MARINE ENVIRONMENT PROTECTION  
COMMITTEE  
80th session  
Agenda item 4

MEPC 80/4/17  
12 May 2023  
Original: ENGLISH  
Pre-session public release:

## HARMFUL AQUATIC ORGANISMS IN BALLAST WATER

### Comments on document MEPC 80/4/8

**Figure 1: Proposed CWQ procedures**

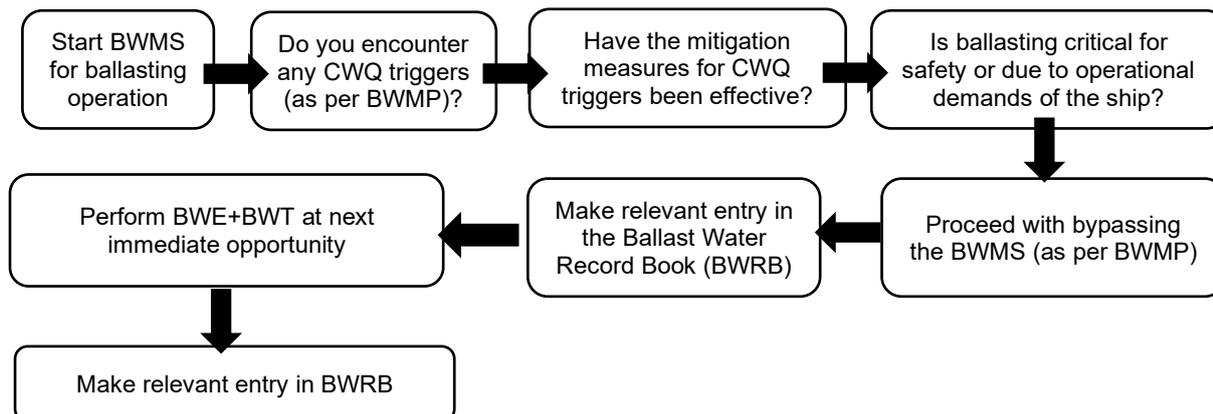
15 The proposed CWQ procedures as reflected in figure 1 in the annex to document MEPC 80/4/8 and in the four process diagrams in the appendix to that annex are overly complicated. The co-sponsors propose for the Committee to consider a simplified process, as reflected in the figure below.
